Driveway/Entrance Permit

Permit Number: 15947 - Entrance ID: 1

PROJECT TITLE: SOLID WASTE PROCESSING FACILITY HAMPDEN, MAINE	DWG: 1 OF 1	BY: BLQ	REV:	DESCRIPTION:	CES INC Engineers • Environmental Scientists • Surveyors
		DATE: 2015-05-14	REV DATE:		
SHEET TITLE: PROPOSED ACCESS ROAD INTERSECTION AT COLDBROOK ROAD	JN: 10973.003	APPROVED BY:	ISSUE:	DESCRIPTION:	
	SCALE: 1:40	CHECKED BY:	ISSUE DATE:

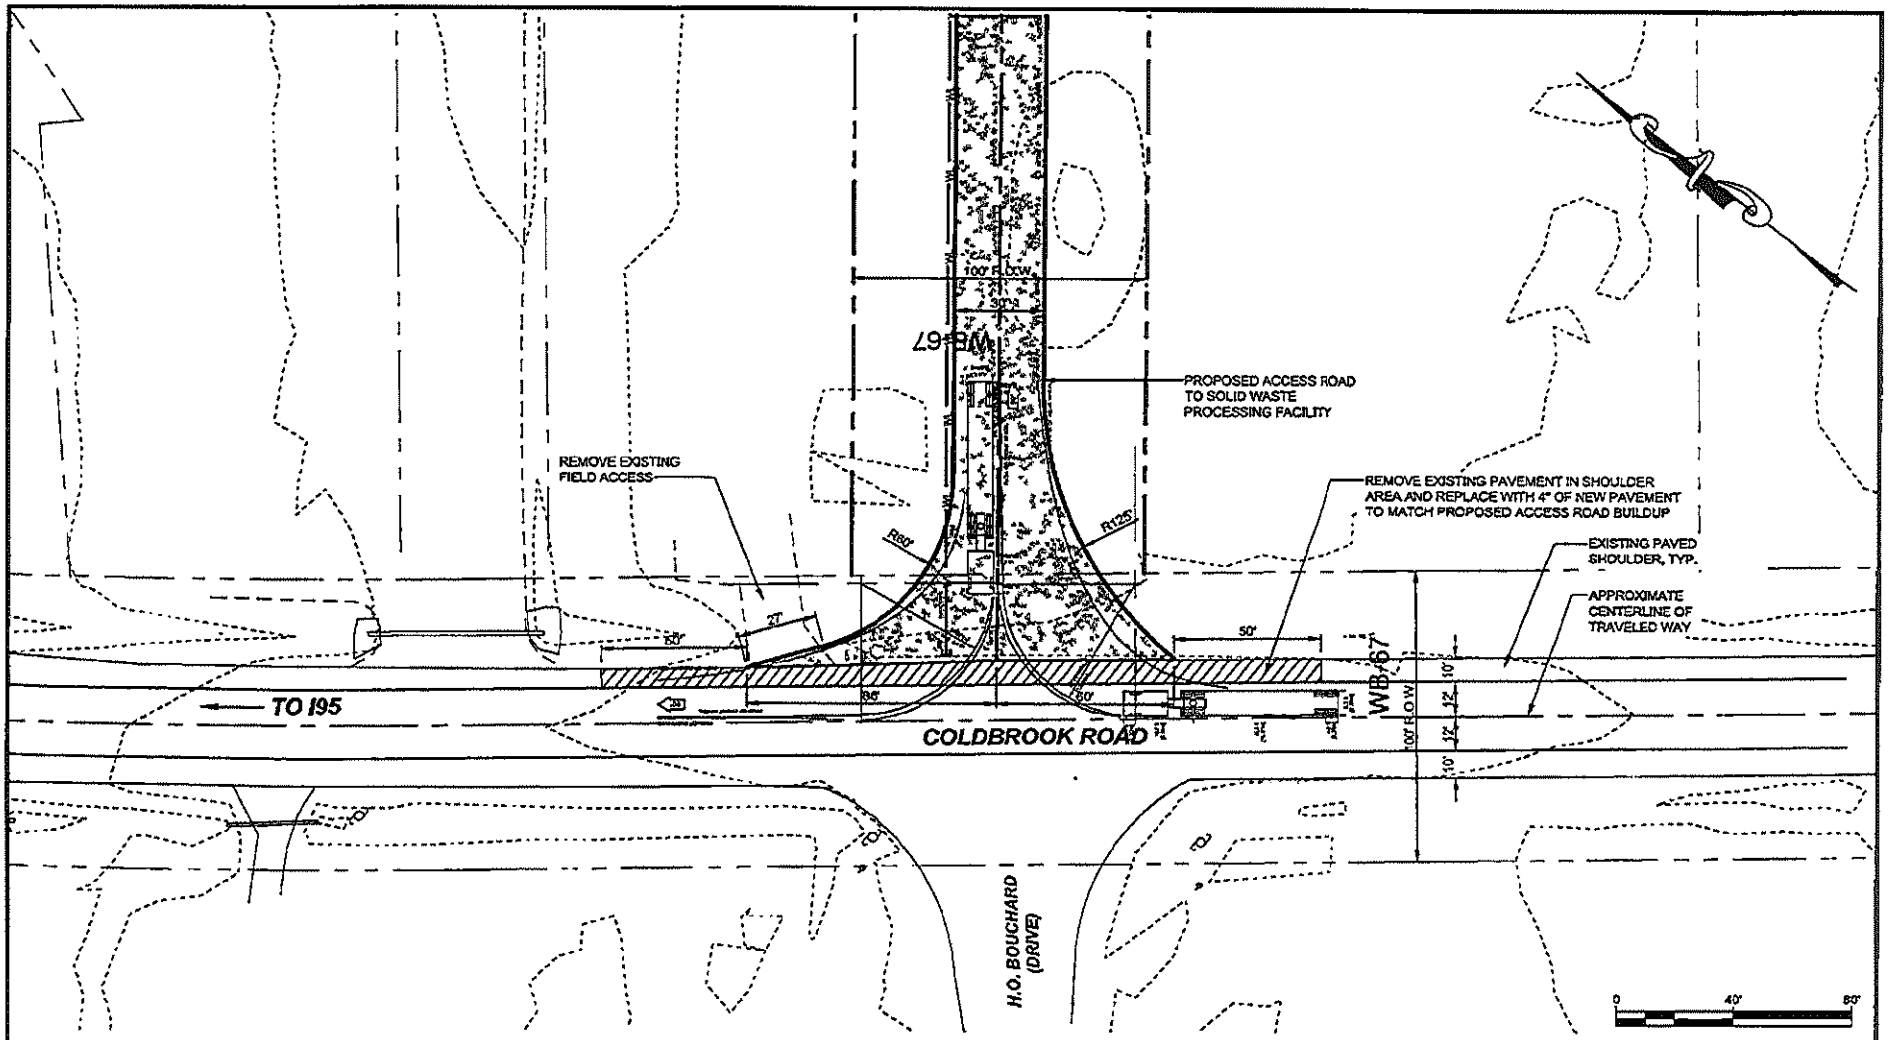
S - Proposed entrance will need an over sized 36 inch STOP sign.

S - Truck Entering signs must be placed on Coldbrook Rd 300 feet on either side of proposed entrance.

S - Entrance to be built to the revised plan of C.E.S. dated 5/14/2015, attached. The plan shows that the shoulder on Coldbrook Road needs to be removed for approximately 250 feet and strethened with 4 inches of new pavement to support truck loads.
